Access Compliance Report Public Rights-of-Way (Curb Ramps)

Main Street: THERESA_AVE Cross Street: THISTLE_RD Location: S

ADA ID: RPRK210924174411 Ramp Type: Type 6 - Directional 1 Initial Pass/Fail: Pass Overall Compliance: No Severity Score: 6

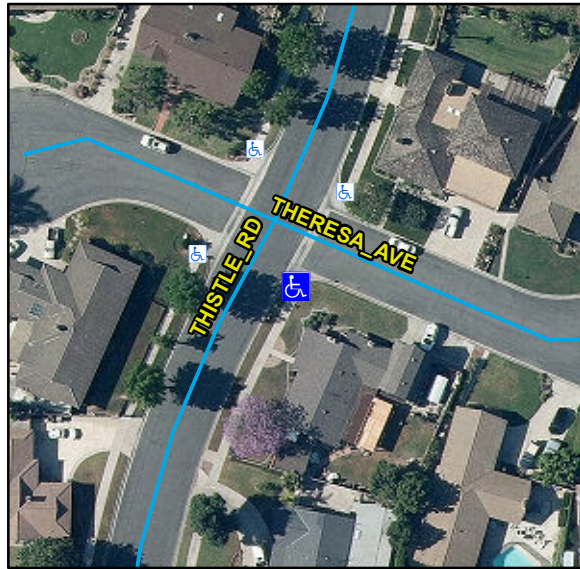
Remove & Replace Curb Ramp With Two New Directional Ramps or Equivalent. Remove & Replace Gutter.
